**City of Portland, Maine – Building or Use Permit Application** 389 Congress Street, 04101, Tel: (207) 874-8703, FAX: 874-8716

DATE: 26 Dec. 98 ADDRESS: 75 Woodvale ST. CBL 277-A-A-020  
REASON FOR PERMIT: To Construct 24'x24' garage 3 rooms above. (Attached.)  
BUILDING OWNER: Mark Deane  
CONTRACTOR: A. Peter Dougherty  
PERMIT APPLICANT: ↑  
USE GROUP R-3 BOCA 1996 CONSTRUCTION TYPE 5B

LAND USE - ZONING REPORT

REASON FOR PERMIT: Construct garage with 2nd floor

EXISTING BASEMENT

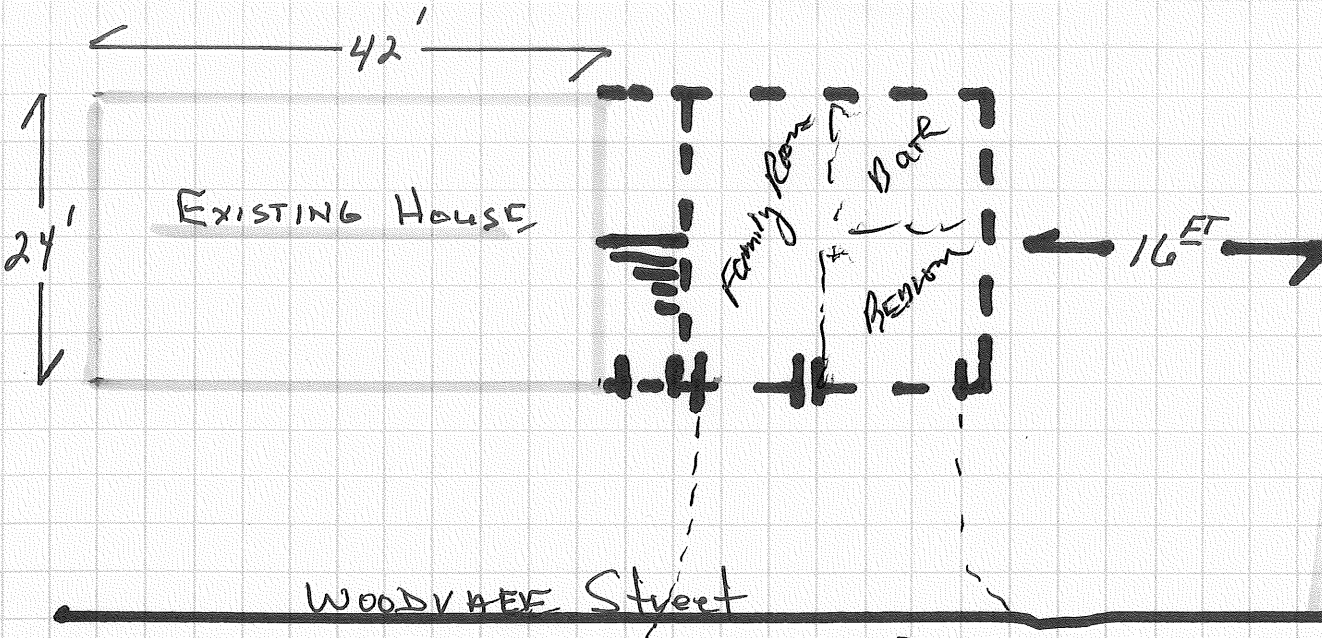
DEAN  
(R-3 Zone) 25' rear req. - 25' + shown  
25' front req. - 25' exactly is shown  
2 story - 14' side yd req.

10. Other requirements of condition your plot plan on the original house shows a 25' setback. Your new garage shall be setback 25' from your front property line - not the curb line, not the street line but your actual property line. 25' is also required from your rear property line.
